UNITED STATES PATENT AND TRADEMARK OFFICE

APPLICATION NO.	FILING DATE	FIRST NAMED INVENTOR	ATTORNEY DOCKET NO.	CONFIRMATION NO.
10/780,512	02/17/2004	Tai-Chun Huang	TS03-461	1383
42717	7590	09/19/2005	EXAMINER	
HAYNES AND BOONE, LLP 901 MAIN STREET, SUITE 3100 DALLAS, TX 75202			CHU, CHRIS C	
			ART UNIT	PAPER NUMBER
			2815	
DATE MAILED: 09/19/2005

Office Action Summary

DETAILED ACTION

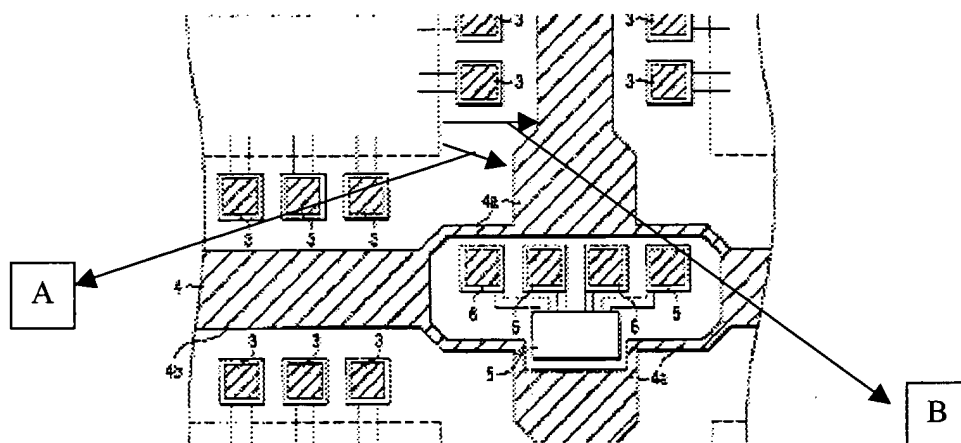
Regarding claim 16, Tsuji et al. discloses in Figure and column 2, lines 45 – 67 a semiconductor device (1; column 2, line 46) comprising:

- semiconductor device structures (any structures inside of the element 4) formed in and on a substrate; and
- a seal ring (4; column 1, line 58 – 60 and Figure show corners and sides of four chips that are separated by the lines 4. Thus, the lines 4 that cover the every corners and sides of a single chip's board lines read as a continuous seal ring.) enclosing said semiconductor device structures forming a single die (2; column 2, line 51),
- wherein a first distance (A) between said semiconductor device structures and a corner portion of said seal ring is smaller than a second distance (B) between said semiconductor device structures and an edge portion of said seal ring (see Figure below).

Regarding claim 21, Tsuji et al. discloses in Figure said corner portion (4a; column 2, line 54) of said seal ring (4) having a first width and wherein said edge portion (4b; column 2, line 55) of said seal ring has a second width wherein said first width is wider than said second width (see Figure and column 2, lines 54 – 56).

Regarding claim 23, Tsuji et al. discloses in Figure only a portion of said corner portion of said seal ring having a width wider than said second width (see the Figure).

Regarding claim 25, Tsuji et al. discloses in Figure one or more slots or holes (at the area where the elements 5 and 6 are formed) being formed in said corner portion (4a) of said seal ring (4).

Regarding claim 2, Tsuji et al. discloses in Figure said metal lines (4a and 4b) being parallel to said edges (the broken lines in the element 1) of said die (2) and wherein said metal lines are sloped at said corner of said die so that said metal lines do not have a “sharp” corner (see Figure).
